**Economic and Social Council**Distr.: General
18 December 2020

Economic Commission for Europe**Inland Transport Committee****World Forum for Harmonization of Vehicle Regulations****183rd session**

1958 Agreement:**Consideration of draft amendments to existing****UN Regulations submitted by GRVA****Proposal for Supplement 2 to the 01 series of amendments to
UN Regulation No. 152 (AEBS for M₁ and N₁)****Submitted by the Working Party on Automated/Autonomous and
Connected Vehicles ***

The text reproduced below was adopted by the Working Party on Automated/Autonomous and Connected Vehicles (GRVA) at its seventh session in September 2020 (ECE/TRANS/WP.29/GRVA/7, paras. 54-55). It is based on ECE/TRANS/WP.29/GRVA/2020/27. It also takes into account the decisions of the World Forum for Harmonization of Vehicle Regulations (WP.29) at its November 2020 session as well as guidance by GRVA at its December 2020 session. It is submitted to WP.29 and to the Administrative Committee (AC.1) for consideration at their March 2021 sessions.

Figure 1

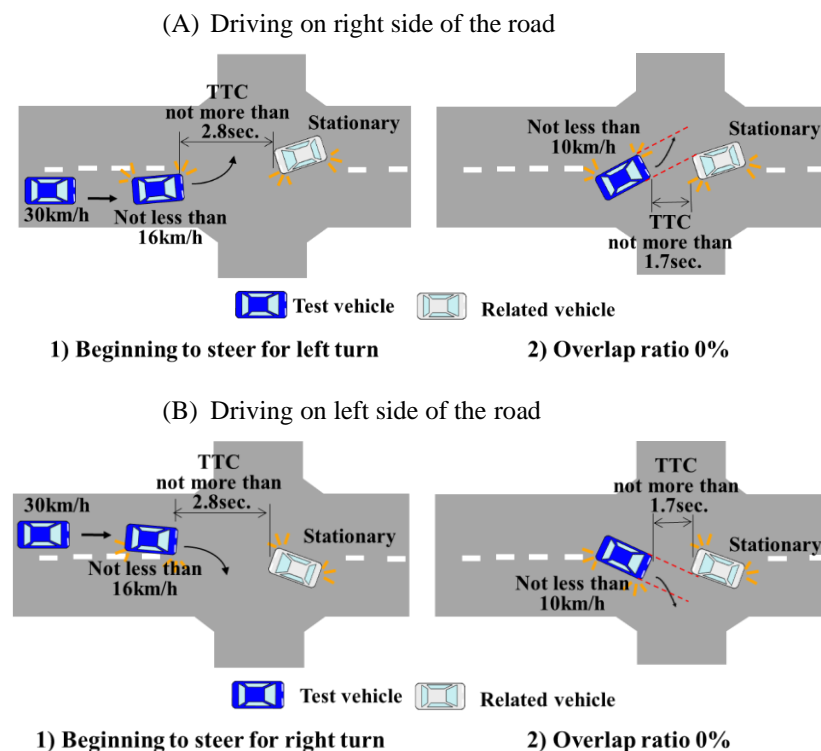
"Scenario 1

Left turn or Right turn at the intersection

- 1.1. In this scenario, the subject vehicle passes by a left turn or right turn in front of an oncoming vehicle that is stopped to make a left turn or right turn at an intersection.
- 1.2. An example of the detail scenario:

The subject vehicle drives at a speed of 30 km/h (with a tolerance of +0/-2 km/h) toward the intersection, and decelerates by braking to a speed of not less than 16 km/h at a point where the subject vehicle begins to steer left / right, and the Time To Collision (TTC) to the oncoming vehicle is not more than 2.8 seconds. When the subject vehicle turns left or right in the intersection, the speed is reduced to not less than 10 km/h, and then drives at a constant speed. The TTC to the oncoming vehicle is not more than 1.7 seconds at when the overlap ratio between the subject vehicle and the oncoming vehicle becomes 0 per cent.

Figure 2

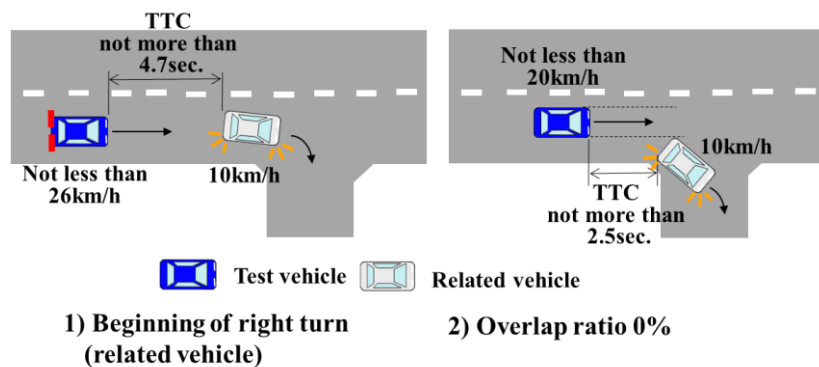
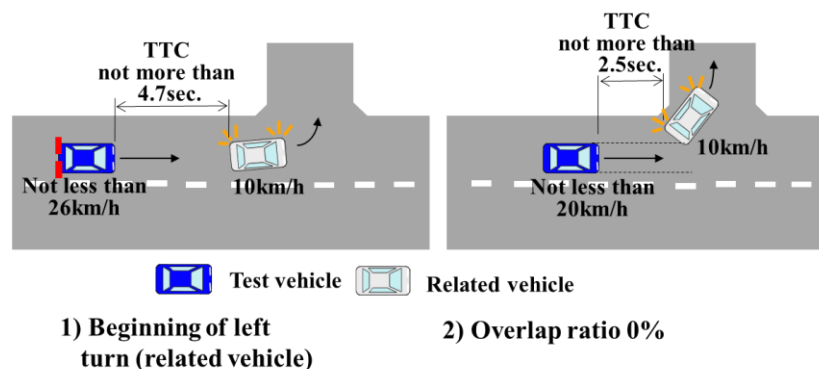
Scenario 2

Right turn or Left turn of a forward vehicle

- 2.1. In this scenario, the subject vehicle follows a forward vehicle. After that, the forward vehicle turns right or left at a corner, and the subject vehicle goes straight.

- 2.2. An example of the detail scenario:
- Both the forward vehicle and the subject vehicle drive at a speed of 40 km/h (with a tolerance of +0/-2 km/h) on the straight road. The forward vehicle decelerates by braking to a speed of 10 km/h (with a tolerance of +0/-2 km/h) in order to turn right or left at the corner, and the subject vehicle also decelerates by braking to keep appropriate distance with the forward vehicle. At when the forward vehicle begins to turn right or left, the speed of the subject vehicle is not less than 26 km/h and the TTC to the frontal vehicle is not more than 4.7 seconds. After that, the subject vehicle decelerates to a speed of not less than 20 km/h, and then drives at a constant speed. The TTC to the forward vehicle is not more than 2.5 seconds at when the overlap ratio between the subject vehicle and the forward vehicle becomes 0 per cent.

Figure 3
Curved road with guard pipes and a stationary object

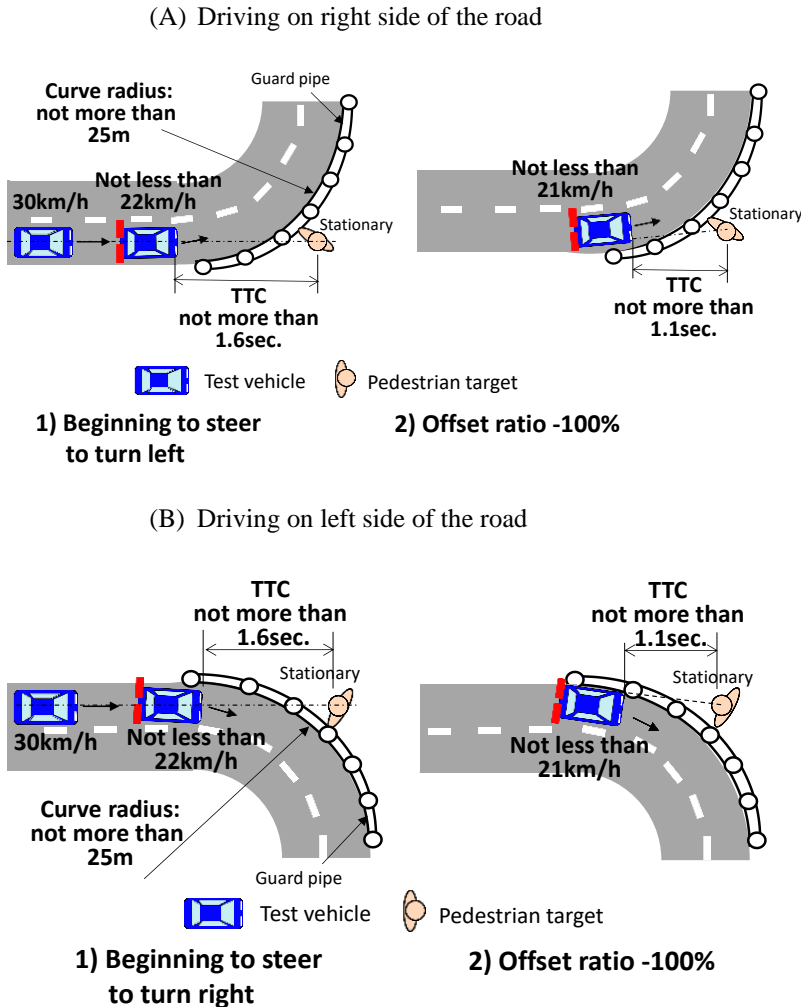
Scenario 3

Curved road with guard pipes and a stationary object

- 3.1. In this scenario, the subject vehicle drives a small radius curved road of which the guard pipes are constructed to the outer side, and a stationary vehicle (M₁ category), a stationary pedestrian target or a stationary bicycle target is positioned just outside of the guard pipes and where on the extension of the centre of the lane.

- 3.2. An example of the detail scenario:
 The subject vehicle drives at a speed of 30 (with a tolerance of +0/-2 km/h) km/h toward the curve of which the radius is not more than 25 m at the outer side of the road, and decelerates by braking to a speed of not less than 22 km/h at a point where the subject vehicle enters the curve. The TTC to the stationary object is not more than 1.6 seconds at when the subject vehicle begins to turn in the curve. In the curve, the subject vehicle drives outer lane than the centre of the road. After that, the subject vehicle continue to turn in the curve at a constant speed of not less than 21 km/h. The TTC to the stationary object is not more than 1.1 second at when the overlap ratio between the subject vehicle and the stationary vehicle becomes 0 per cent, or at when the offset ratio between the subject vehicle and the centre of the stationary pedestrian target or the stationary bicycle target becomes -100 per cent.

Figure 4

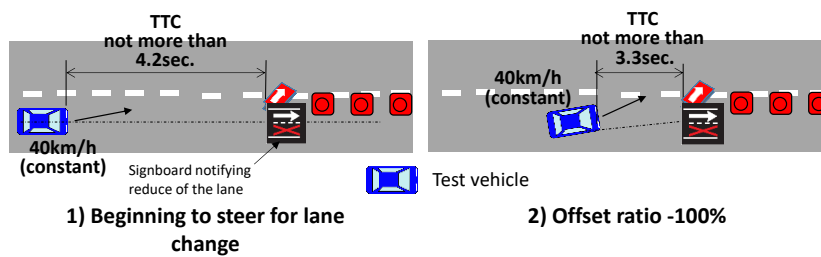
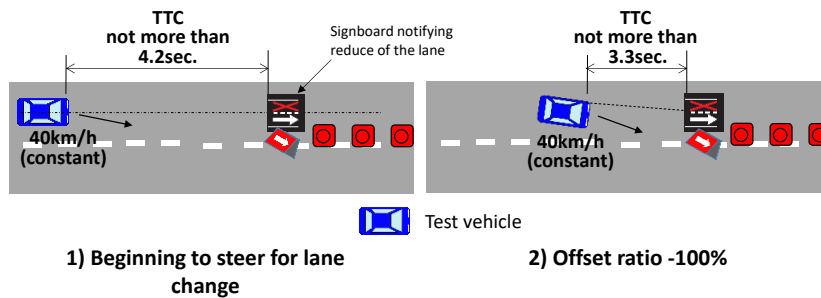
Scenario 4

Lane change due to road construction

4.1. In this scenario, the subject vehicle changes the lane in front of the signboard which is positioned in the centre of the lane and notifies the driver that the lane is reduced.

The subject vehicle drives a straight road at a speed of 40 km/h (with a tolerance of +0/-2 km/h) and begins to steer in order to change the lane in front of the signboard which notifies reducing the lane. No other vehicles approach the subject vehicle. The TTC to the signboard is not more than 4.2 seconds at when the subject vehicle begins to steer. During changing the lane, the speed of the subject vehicle is constant, and the TTC to the signboard is not more than 3.3 seconds at when the offset ratio between the subject vehicle and the centre of the signboard becomes -100 per cent.
